Transpower's Ōtāhuhu- Whakamaru A and B line reconductoring listed project application

Final decision - reasons paper

2 July 2026

Figure C2 Upper North Island transmission network^{70,71}

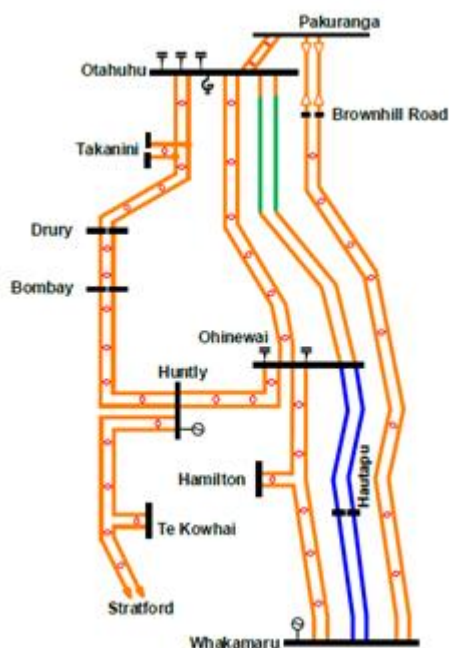
C91 Transpower that this like for like reconductoring cost makes “duplexing the southern section of the OTA-WKM A&B lines and bussing into Ōhinewai substation (see Figure C2) another likely option for the WUNI2 project” which is likely to be submitted to the Commission during 2026.⁶⁹
